TSB#C1701 F13 ERROR CODE (Modcon Models)

**NOTICE: THE FOLLOWING EXPLAINS/CLARIFIES QUESTIONS REGARDING THE
RANDOM F13 ERROR CODE ON PRODUCTS USING AMETEK FANS!
Follow these instructions to identify.**

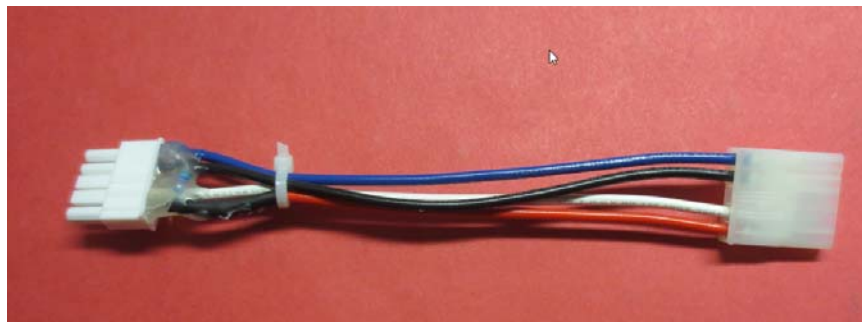
When using Ametek fans like the one shown below, random F13 error codes can occur.

This is caused by minor low stray voltage being picked up by the fan circuit.

A voltage filter (shown below) has been created to correct this. Part # 7350P-800

- Turn power off to the unit

- Unplug the four wire Molex connecting to the fan
 - Plug in the voltage filter (7350P-800) to the fan
- Plug the wire harness into the other end of the voltage filter
 - Turn the power back on

NOTE: If F13 Persists after installing the Voltage Filter, replace fan assembly.
